# HILLS OF GOLD PRESERVATION INC 1800437

## OBJECTION TO THE NOVEMBER 2022 AMENDED DEVELOPMENT APPLICATION FOR HILLS OF GOLD WIND FARM SSD-9679 EXH-50789958

4b

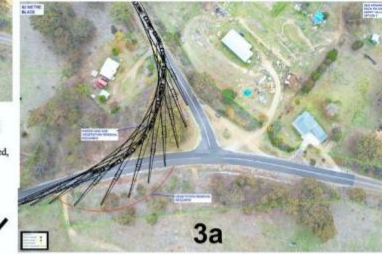
**PROCEDURE:** Left hand turn from Happy Valley Road onto Jenkins Road.  
**GPS LINK FOR SECTION OF ROAD:** <https://goo.gl/maps/9f75wcm6DrQk2Vj8>  
**COMMENTS:** Roads will have reversed along Happy Valley Road from Old Hanging Rock Road and reverse into the landowner's boundaries at the T intersection. Once both are past the intersection they will turn right and continue south onto Jenkins Street.  
**ROAD MODIFICATIONS:** Large amounts of work are required.

4a

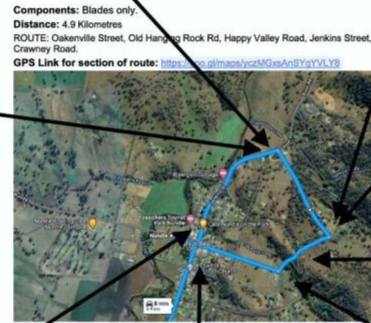
**PROCEDURE:** Left hand turn from Happy Valley Road onto Jenkins Road.  
**GPS LINK FOR SECTION OF ROAD:** <https://goo.gl/maps/9f75wcm6DrQk2Vj8>  
**COMMENTS:** Blades to turn left from the incorrect side to the incorrect side of the road. The swept path will have the blades travel through a landowner's boundaries. This will require a fence to be relocated, hardstand added and a power pole to be relocated. Additionally, a sign will need to be made removable.  
**ROAD MODIFICATIONS:** Large amounts of work are required.

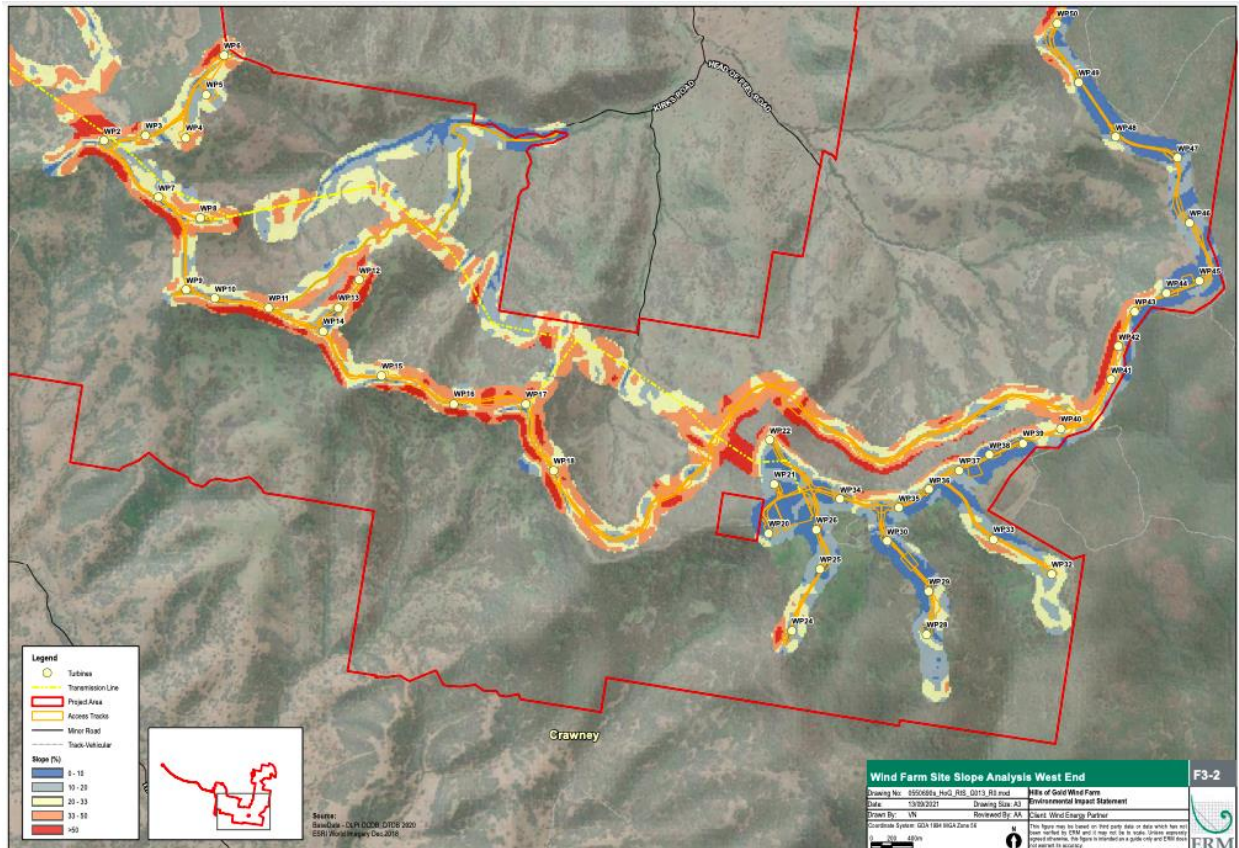
There is no engineering detail provided to demonstrate what is involved in constructing the proposed Western Connector Road or Transverse Track (similar gradients to the Devil's Elbow Private Road, previously rejected by Tamworth Regional Council). The only indication of the gradient of the proposed roads is a Slope Map in the Response to Submissions and topographic maps. DPE independent consultants must physically inspect these proposed roads as part of the constructability assessment process.

Diagram showing the Peel River flood plain at Nundle village, that would impact the proposed raised private road linking Oakenville and Jenkins Street.

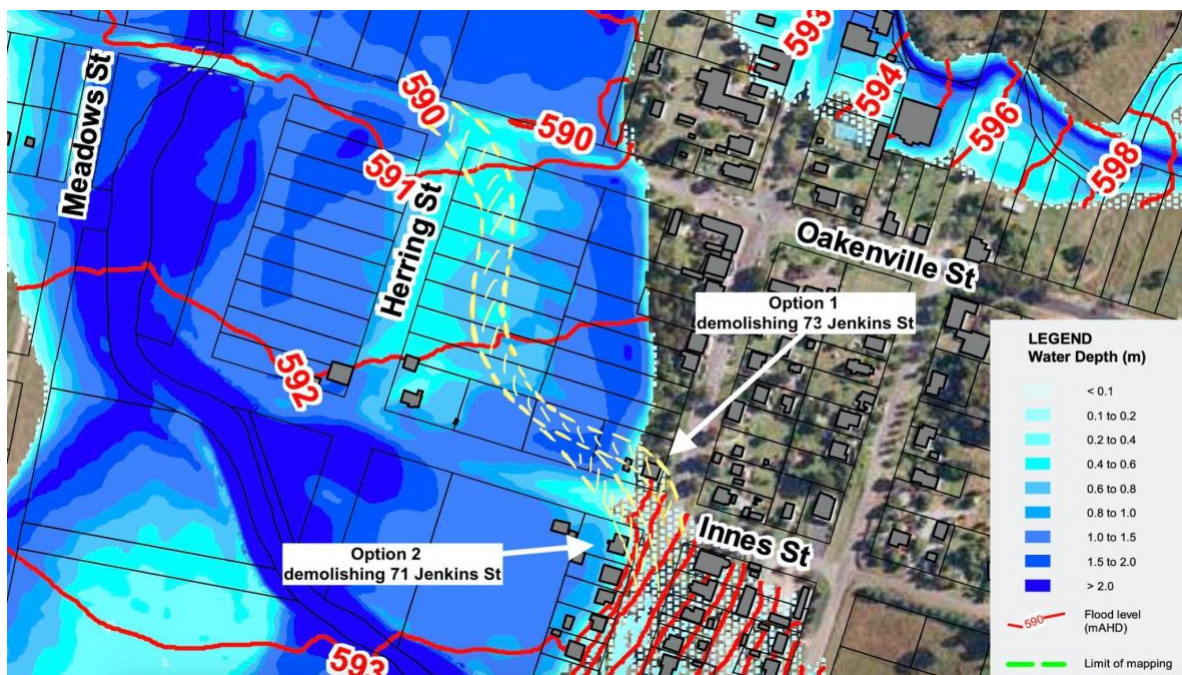
Besides the visual blight, the impact on heritage, urban tree removal, the issue of the waste water dispersal/absorption and the traffic delays due to construction, the proposed raised private road would affect the flow of the flood waters due to this road needing to be built up. This will concentrate flood waters and affect the behaviour and force of flood waters on immediate neighbouring properties and further downstream. Where the water is deepest, just below 73 Jenkins St, the road would need to be built up significantly. This would prevent the water flowing down the familiar path towards and below the pub. This would result in water backing up and the two houses on Herring St would be additionally impacted, as well as the houses along Jenkins street and properties on the western side of the river. It would also result in additional pressure on the bridge and public amenities on the oval.

**Figure B.1.1.2.** Transmission Line (Option 1) Photomontage PM01 (Representative of AD\_74)

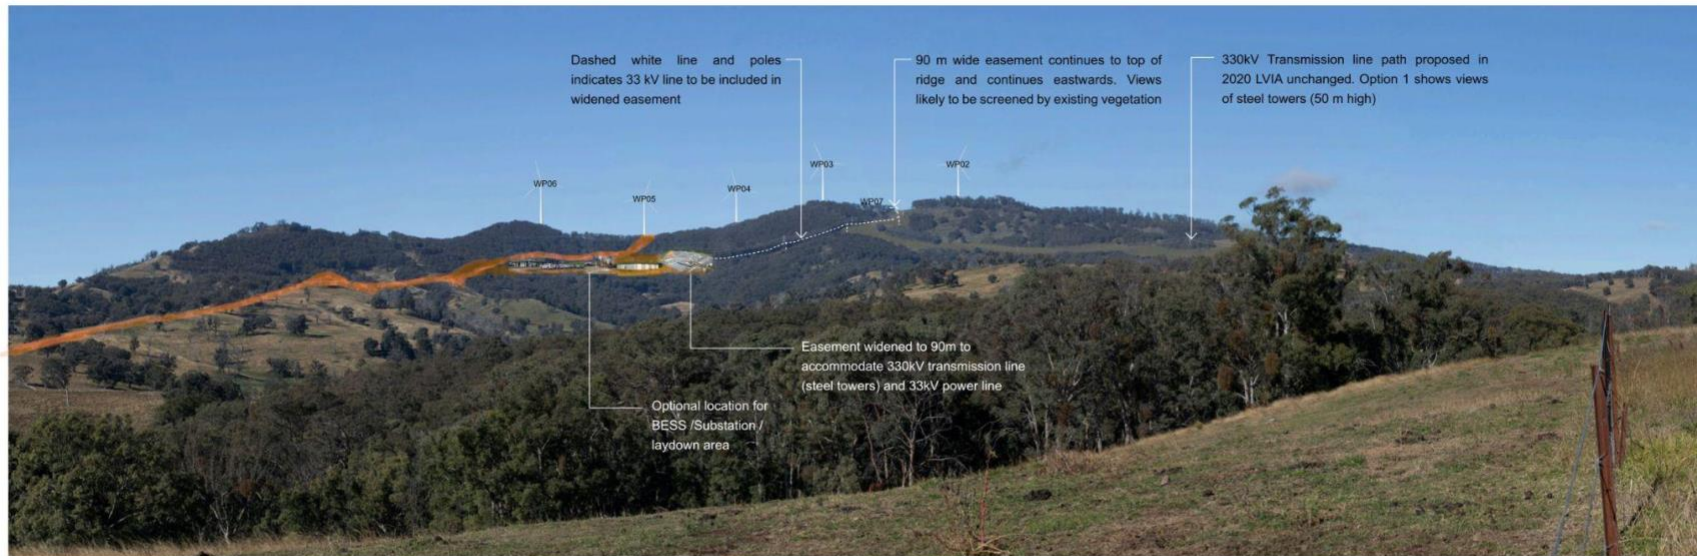
The proponent has not provided an accurate photomontage of changes to the profile of the mountain range required to construct wind turbine foundations, hard stands, 40km of internal roads, cabling, concrete batching plants, operations and maintenance buildings, substation and battery.

Existing photomontages do not give the community an understanding of the required modification of the landscape for this industrial proposal. The photomontages provided depict wind turbines like birthday candles placed in a cake with no alteration to the surface.
